Appendix A – Alignment Selection Report on Consultation

Spittal – Loch Buidhe – Beauly 400kV Overhead Line

Alignment Report on Consultation

January 2025

Figure 1: Potential and Alternative Alignment Options presented during consultation

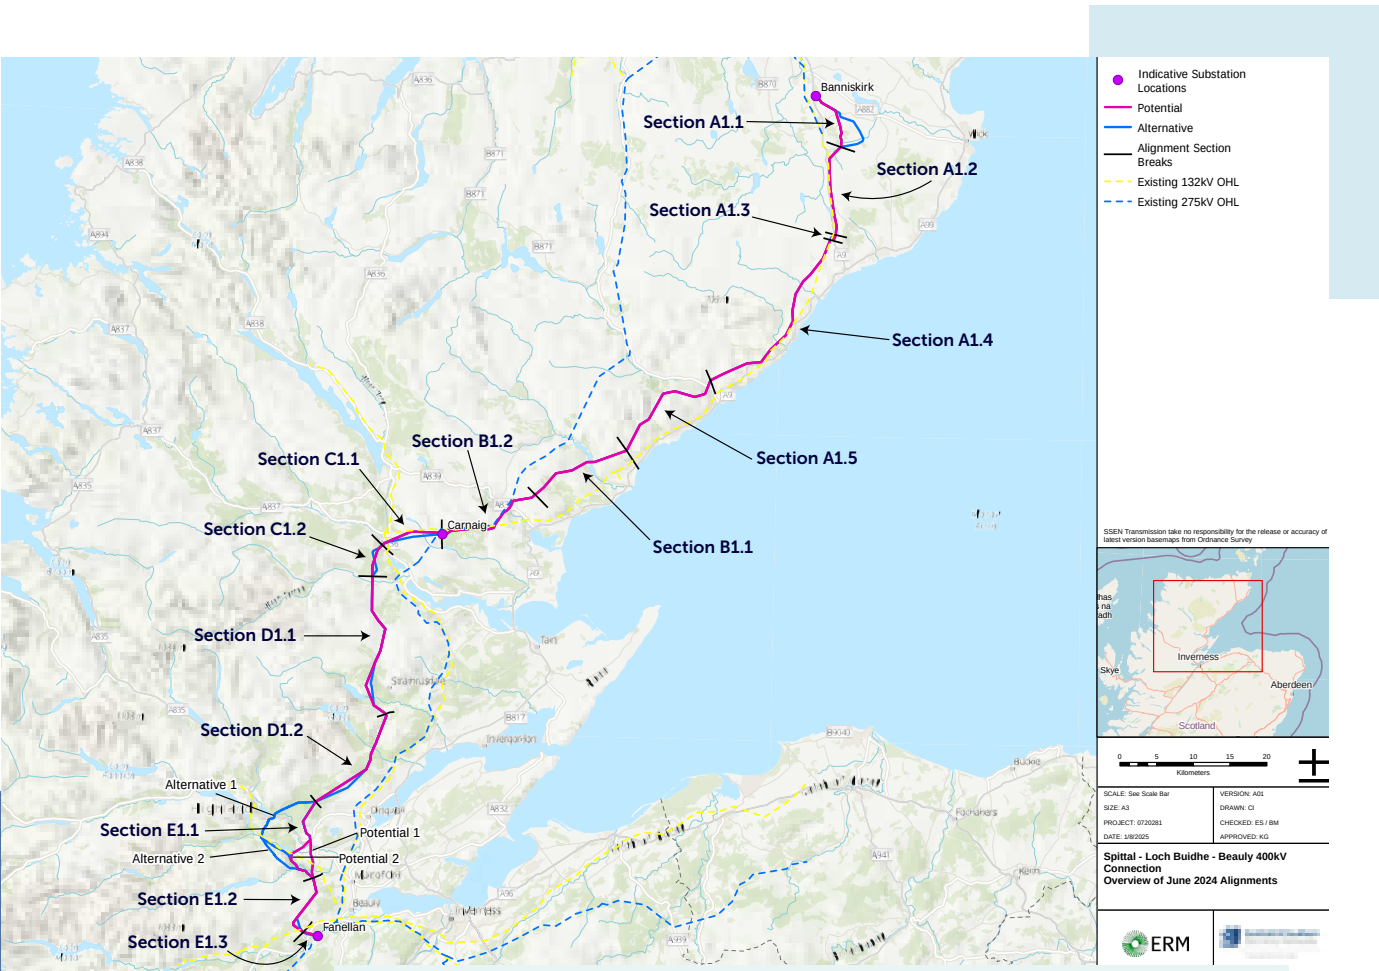
The consultation explained how we believe the Potential Alignment, shown in pink in Appendix B, offers the best balance of technical and environmental impact considerations identified through internal assessment and previous public and statutory consultation on route options. This was then subject to further consultation with stakeholders, where local and previously unknown considerations may confirm or alter the initial preference.

Figure 2: Overview of Proposed Alignments

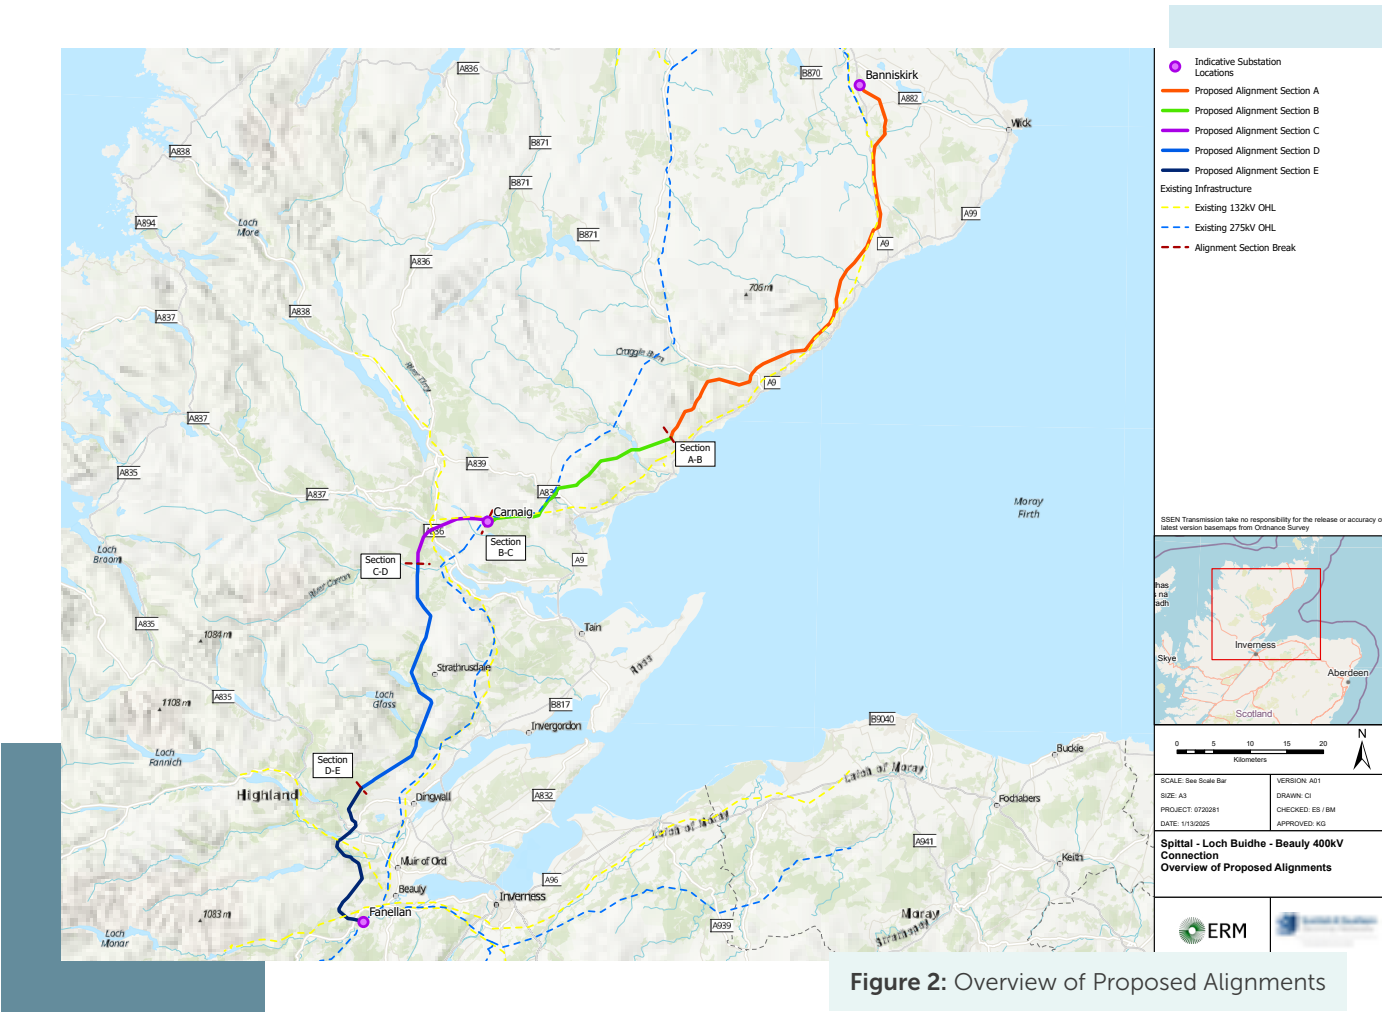
Potential Alignment E1.2 is preferred over Alternative Alignment E1.2 when considering both environmental and engineering constraints. Based on the feedback received, the Potential Alignment E1.2 was adjusted to avoid impacts on the schedule monuments northeast of the Breakachy Hill and to minimise impacts on watercourses south of Breakachy Hill.

Potential Alignment E1.3 is preferred over Alternative Alignment E1.3 when considering both environmental and engineering constraints.
